Misc. - 4316 IL Route 22:
Route 22 Widening

To: David Lothspeich
Subject: RE: 4316 IL Route 22 Property Acquisition

Impact Attenuator at End of Retaining Wall

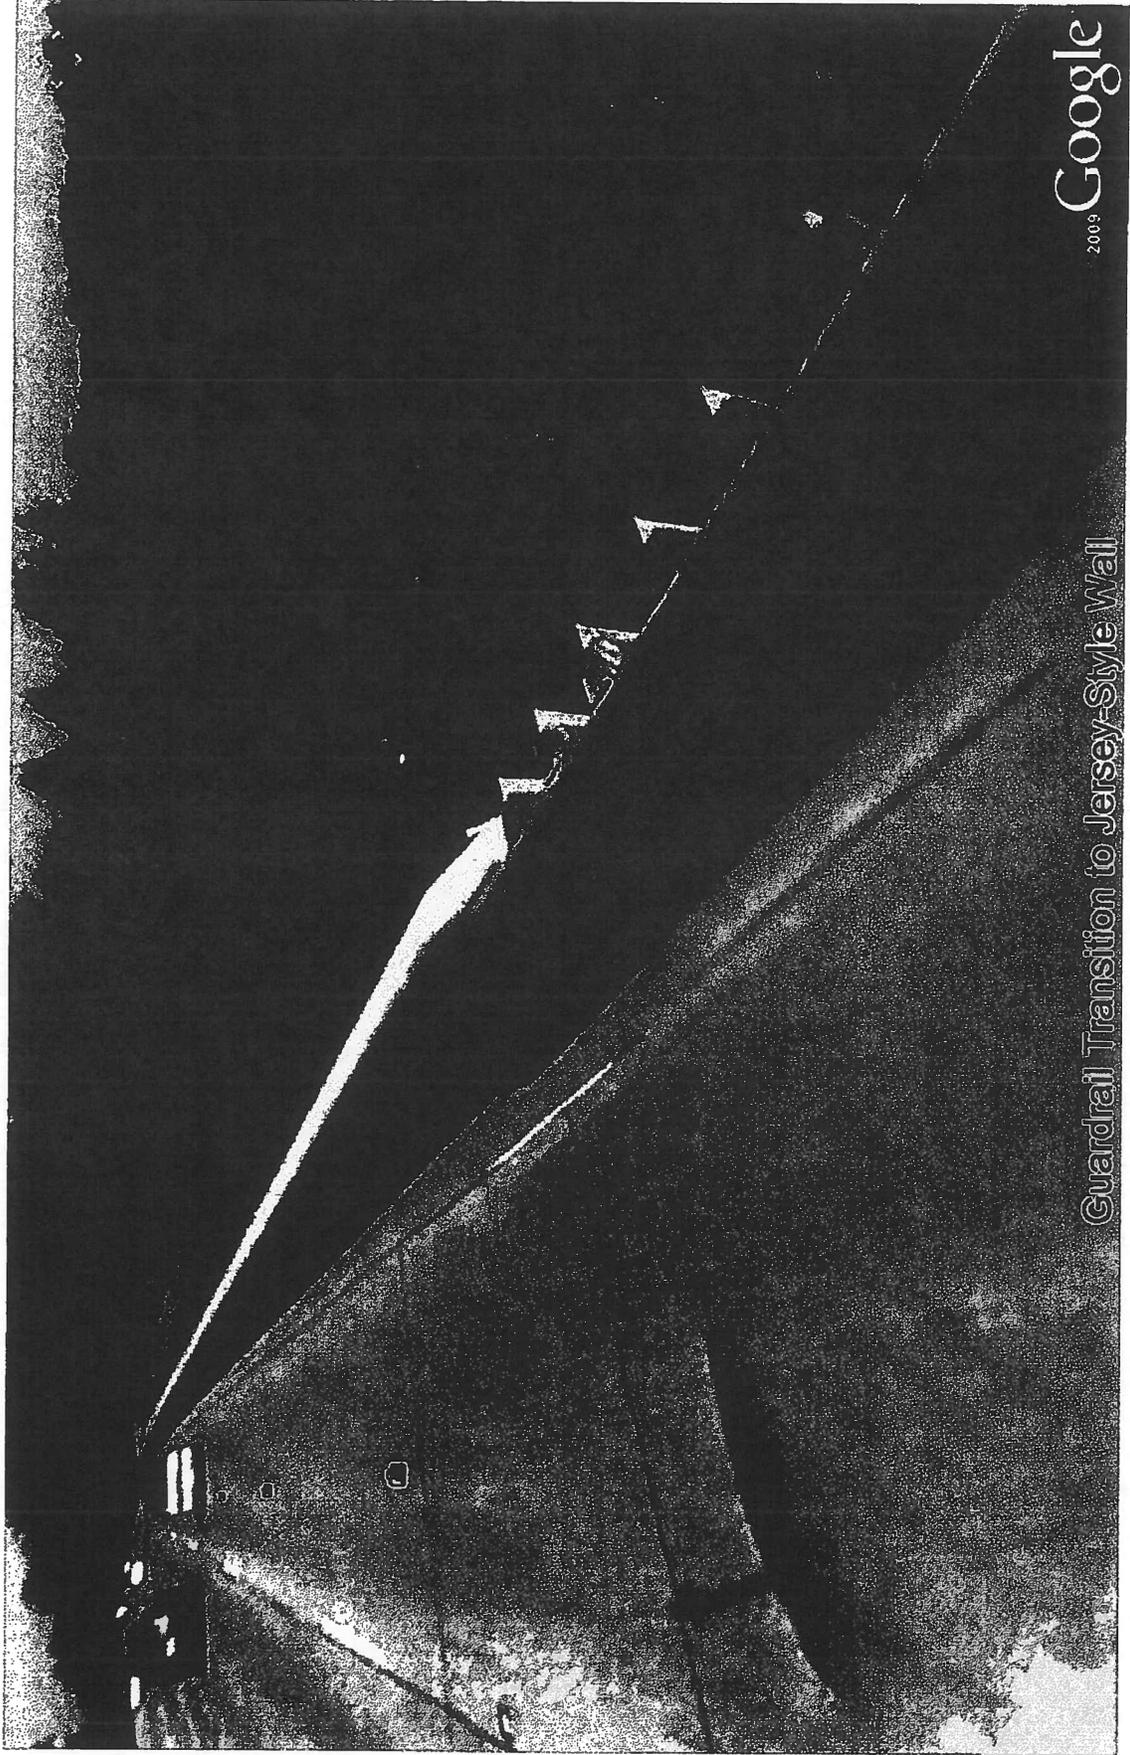
- **Wall #15, Sta. 120+00, RT - SHORTENED** – This fill-section wall was shortened on the east end by allowing some drainage to the roadway over the back of curb since the roadway profile is in a crest section. The remainder of the wall must be kept to avoid encroachment into the SCE. Even with the wall, PE and TE will be required in the SCE at the Oak Creek Lane to allow for a tapered wall for sight distance. Aside from the sight distance taper, this wall will be constructed at the back of the 2-foot concrete gutter along the south edge of pavement. To provide for necessary drainage swales and utilities replacement, it will be a Jersey-style concrete barrier wall, similar to what is constructed on IL Route 22 east of IL Route 21 in Lincolnshire. It will require end protection in the form of impact attenuators or guardrail extending from both ends. See attached photos.

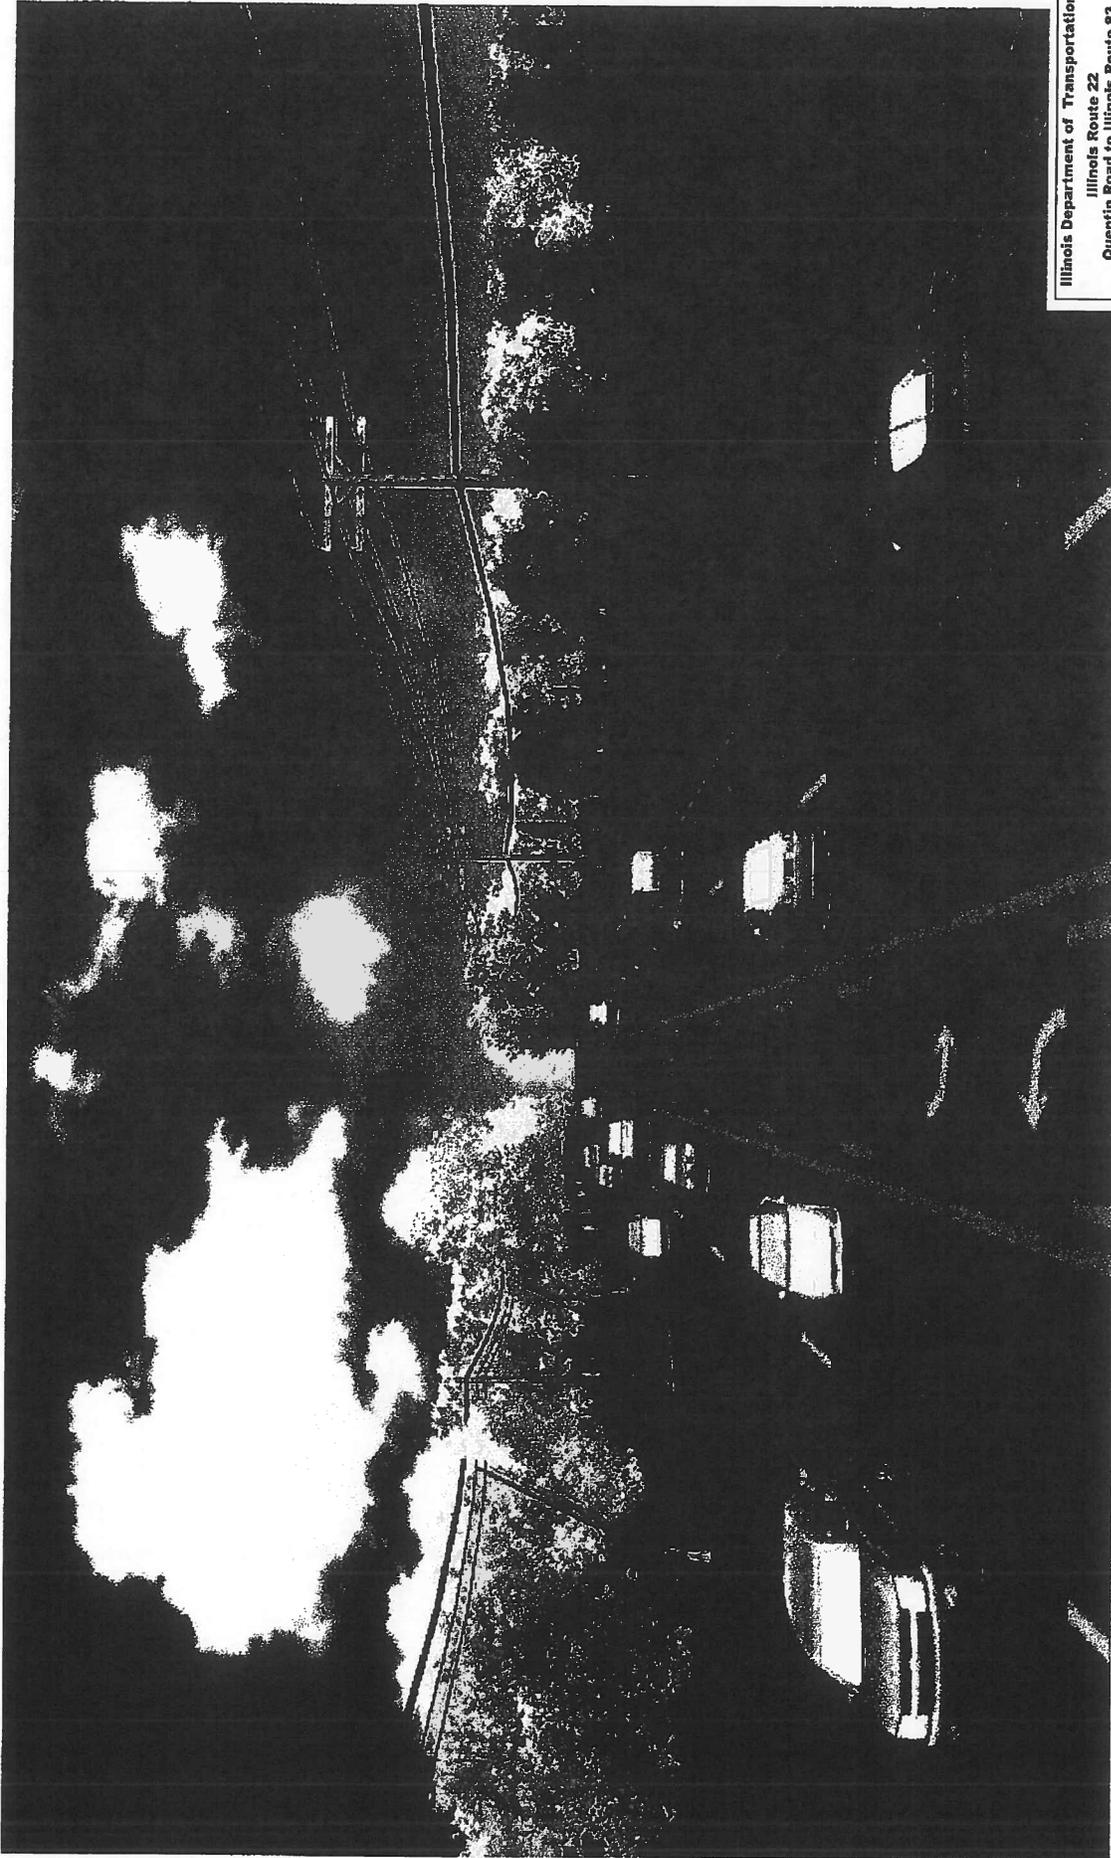
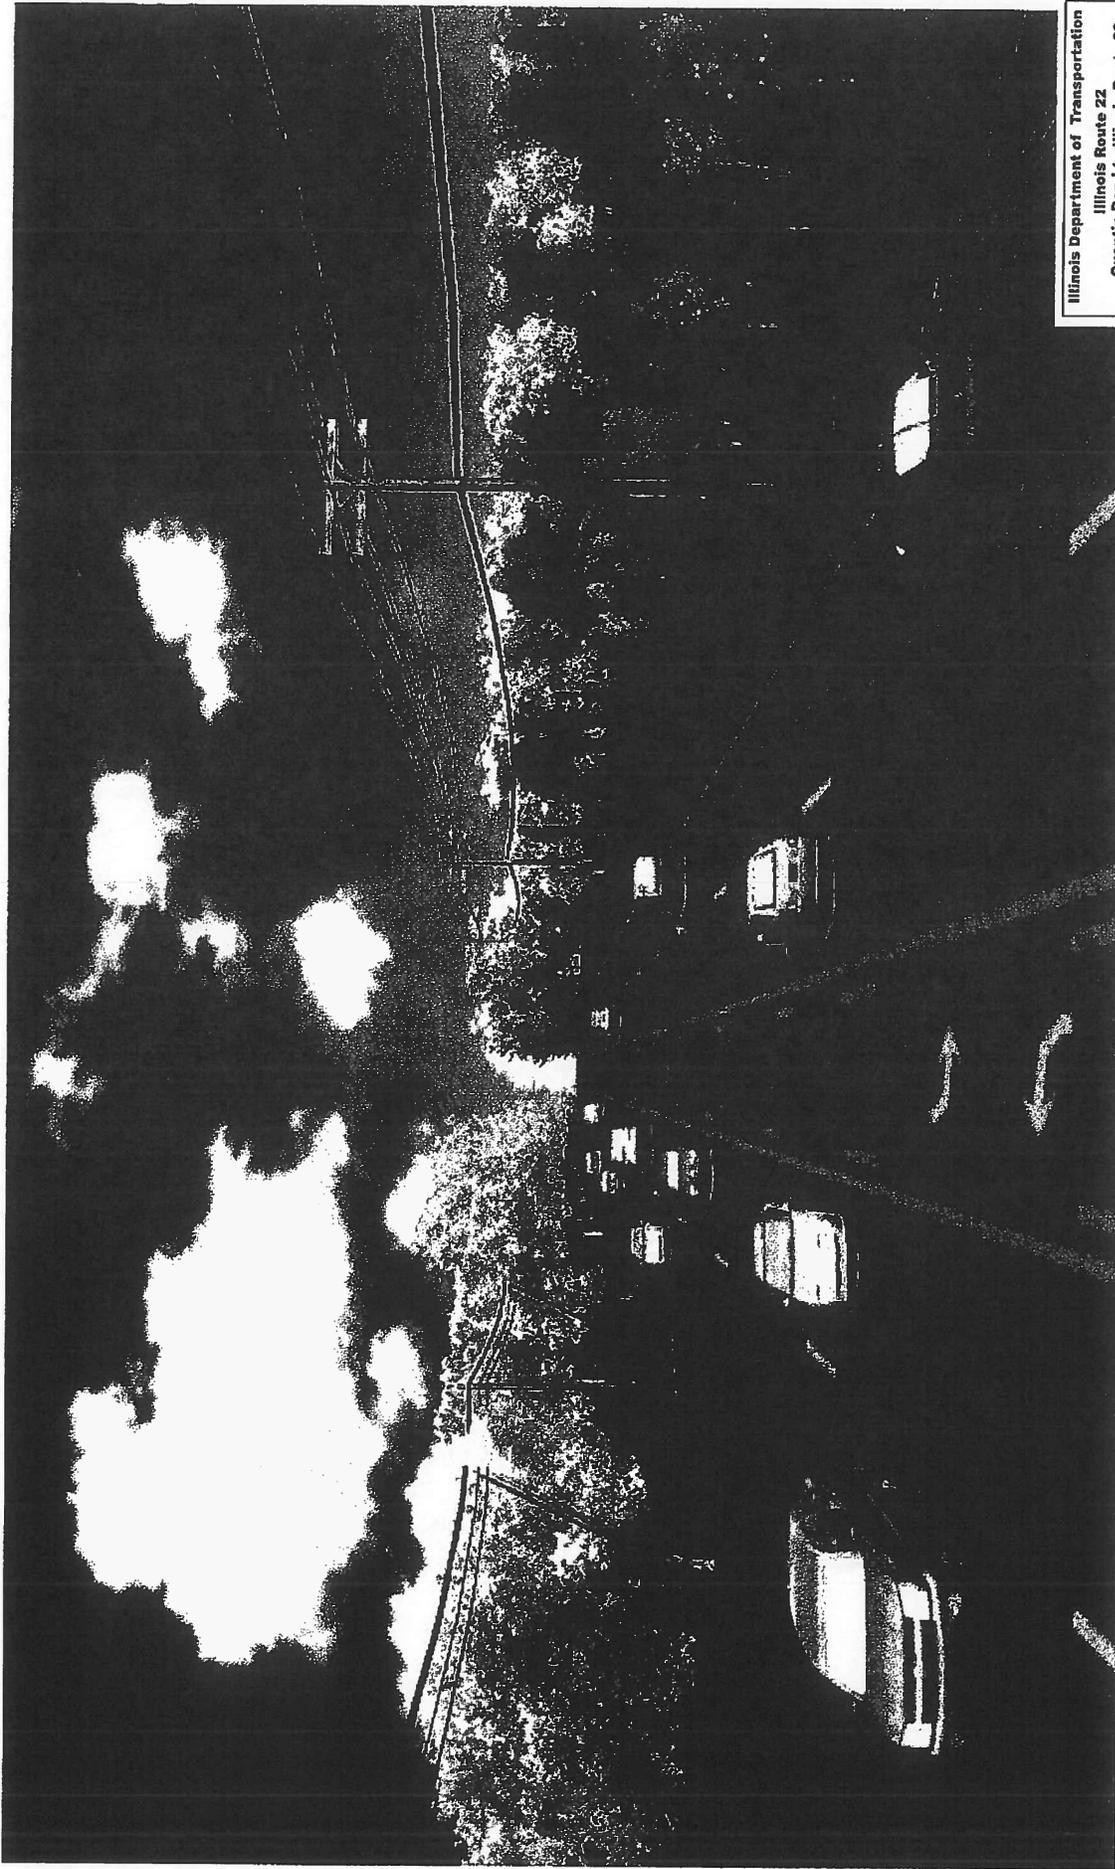
- Attachment D includes rendered typical section exhibits that show a sample location where an optional retaining wall is proposed, to illustrate the future conditions with and without the optional wall. Optional Wall #15 is shown as an example. The viewpoint is near Oak Creek Lane at Sta. 119+00, looking east.

- Exhibit D-4 shows the proposed conditions from "View 1", without the wall, however this condition assumes that the Village allows IDOT to plant replacement trees within the scenic corridor easement.
